**CHANDIGARH
HOUSING BOARD**
A CHANDIGARH ADMINISTRATION UNDERTAKING

Subject : Additional construction / violations in Duplex Flats in Sector 41-A, Chandigarh.

723/1, SEC. 41-A

FIRST FLOOR PLAN

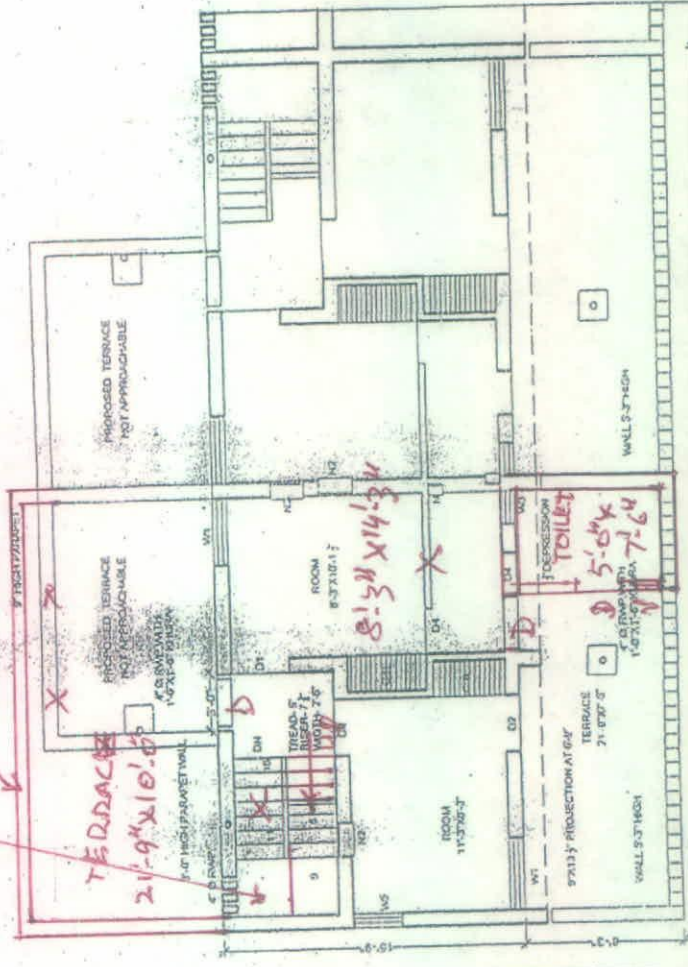
TERRACE FULLY COVERED

RCC ROOF ON BALCONY AT 6'-9" HT.

3'-0" HIGH RAILING

MUMTY REMOVED & RCC ROOF LAID ON STAIR CASE

TERRACE PLAN

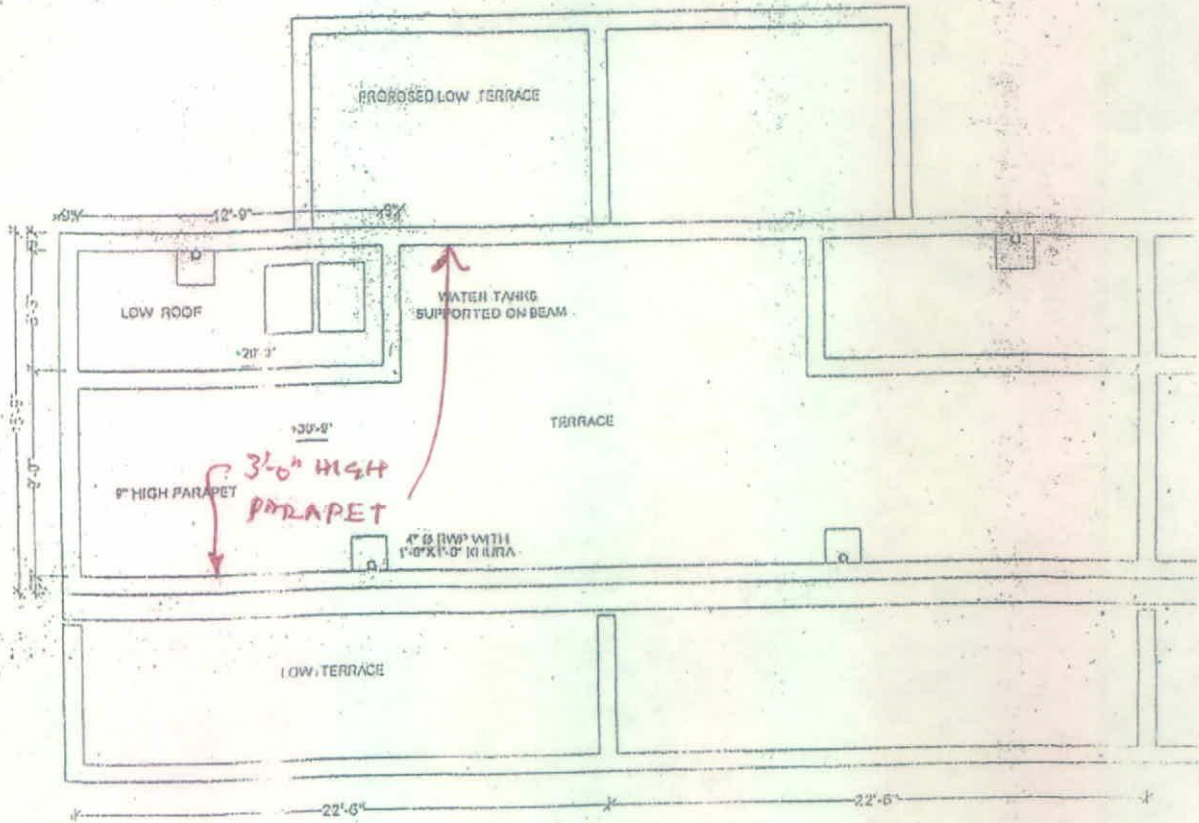
3'-0" HIGH PARAPET

THE DESIGN OF RCC BALCONY SHALL BE AS PER EXISTING IN THE RESPECTIVE DWELLING UNITS
